**Southwest Light Rail Transit: Kenilworth Shallow LRT Tunnels
Water Resources Evaluation**

DRAFT

Metropolitan Council

**Revision 0
January 30, 2013**

Figure 2: Construction Sheet Pile Cell

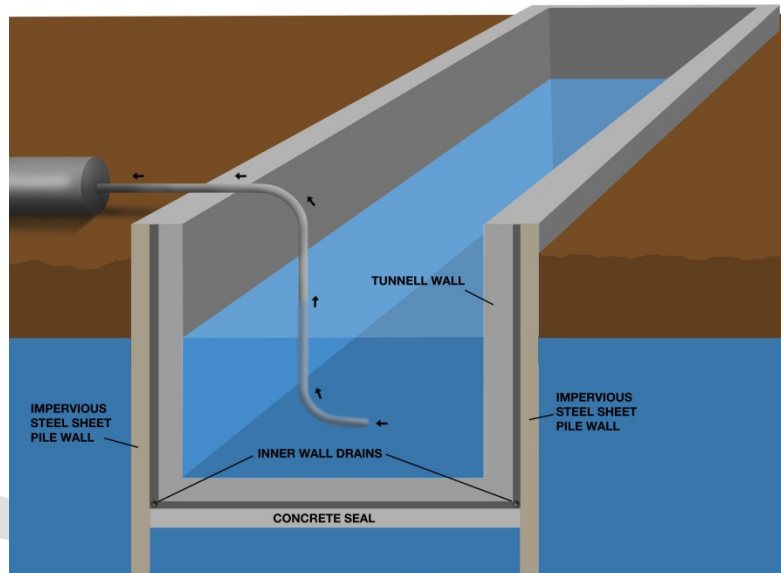
- Based on our understanding of the proposed construction method, the Cell 1 (Excavation) dewatering calculation would not apply because no pumping of groundwater would occur until after the excavation is complete and the concrete seal is in place. At that point the Cell 2 (Construction) scenario would apply.

- Although sealed sheet piling joints are proposed in the BODR, the analysis for groundwater control during construction of the excavation cells appears to assume open joints as stated in the BODR construction sequence.

- The calculation for groundwater removal in the excavation cell factors in the seepage rate for each sheet piling joint, the total number of joints, and the maximum precipitation anticipated to occur during the 15-day construction period. Additionally, this calculation factors in the volume of the cell that is below lake level during the 15-day period. However, when this volume is factored into the calculated pumping rate for the excavation cell a 45-day period is assumed. Groundwater removal from the excavation cell will occur in 15 days as that is the length of time the cell will be under construction. If the 15-day excavation cell period is substituted in place of the 45-day period, the resultant pumping rate is 24.6 gpm, rather than the 10 gpm reported in the BODR.

- For the Cell 2 (Construction) calculation (in which the sheet pile joints will be sealed) a joint resistance of 1.0×10^{-7} m/s is used. A joint resistance of 3×10^{-10} m/s should be used (according to the referenced sheet pile manual). When this factor is applied in the spreadsheet calculation, a pumping rate of 0.6 gpm is the result, rather than 2.4 gpm presented in the BODR.

- The source of the presumed rainfall amounts (6 inches for the excavation scenario and 12 inches for the construction scenario) was not stated. This would be a significant amount of rainfall and, therefore, would likely represent a near-worst case scenario for precipitation. It is recommended that the source of the precipitation amounts used in the calculations be stated.

It is recommended that these rates be thoroughly re-evaluated with clearly stated assumptions, input values, and ranges of calculated values. Additionally, the anticipated long-term performance of the waterproofing system should be evaluated considering its durability and other projects where this system has been used in similar settings.

Figure 6: Groundwater Piezometer Data (Vayen, 2013)

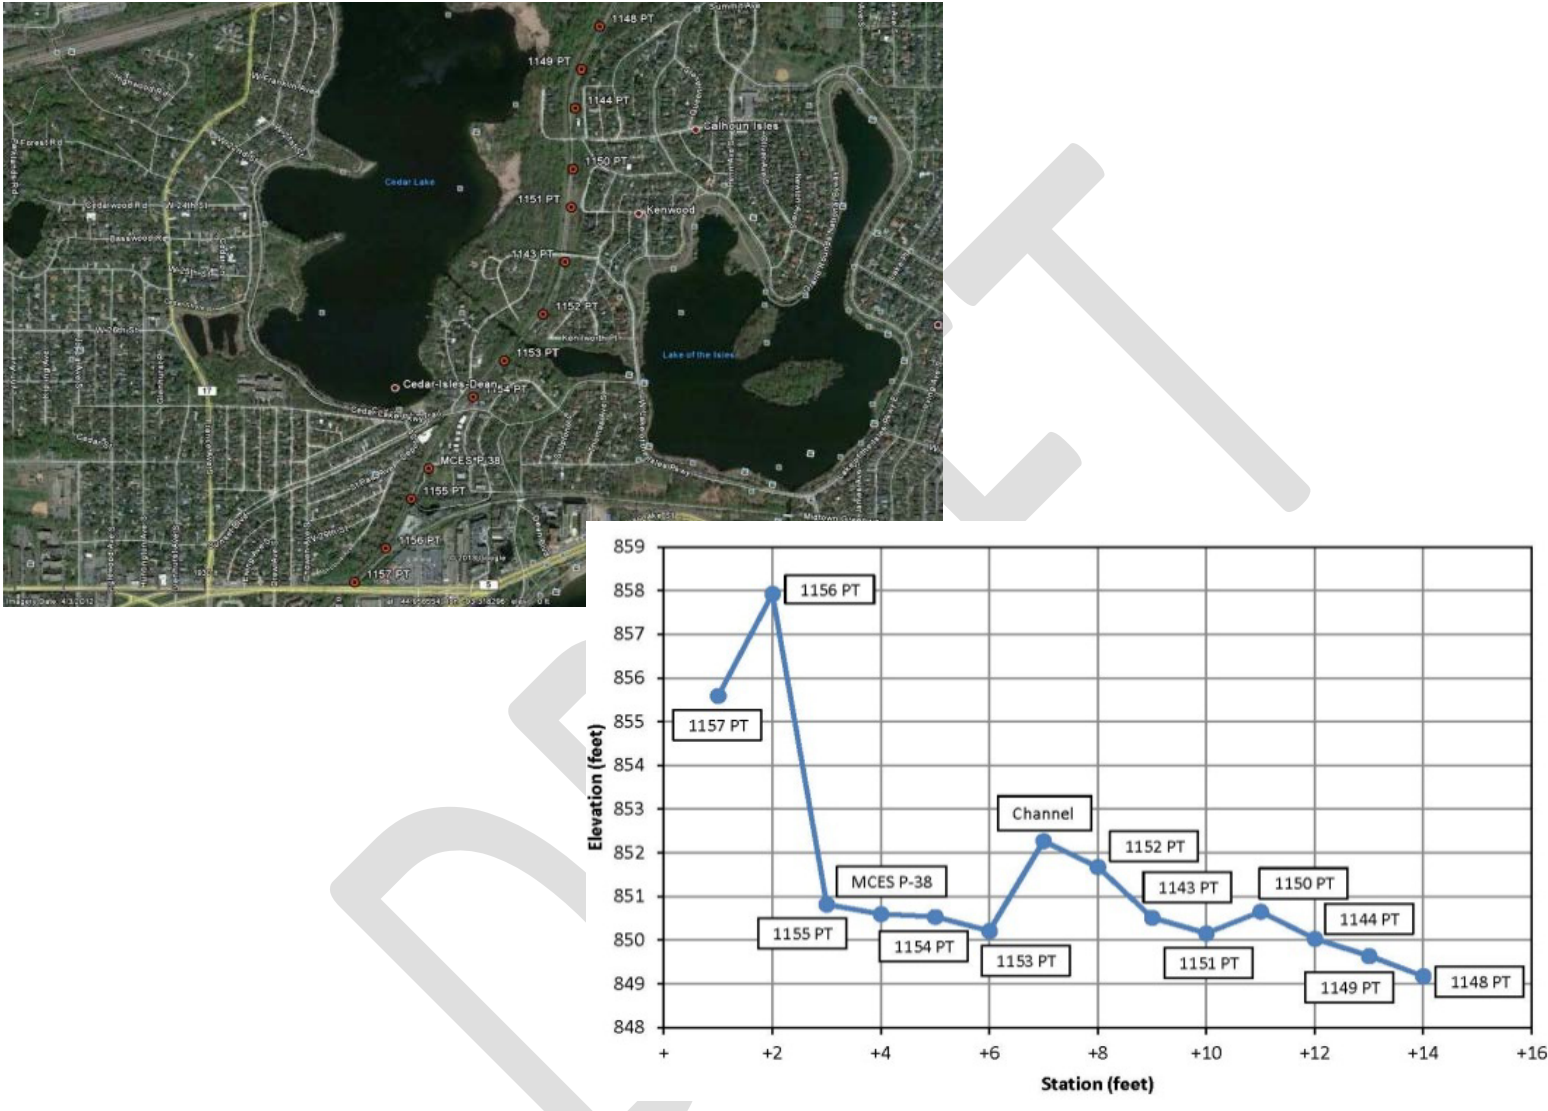
Since the AET piezometers are installed only along the proposed route in the Kenilworth Corridor, they only provide a one dimensional view of the groundwater elevations and it is difficult to conclusively determine the groundwater flow pattern. Additional piezometers lateral to the proposed route are needed to better characterize the groundwater flow system in two dimensions, and a few nested piezometers completed at a greater depth would help to evaluate potential downward flow. Also, the water levels presented are only from October and November 2014. Seasonal water level data are needed to better understand ground water elevations during wet periods and in response to rain events.

- Additional piezometers lateral to the planned route both north and the south of the channel are needed to better characterize the groundwater flow system in two dimensions. Also some sets of nested piezometers should be installed to evaluate vertical groundwater flow in the Kenilworth Corridor. This will help to better characterize and understand the direction and gradient of groundwater flow and the interaction between groundwater and surface water. Also, seasonal water level data are needed to better understand ground water elevations during wet periods and in response to rainfall events.
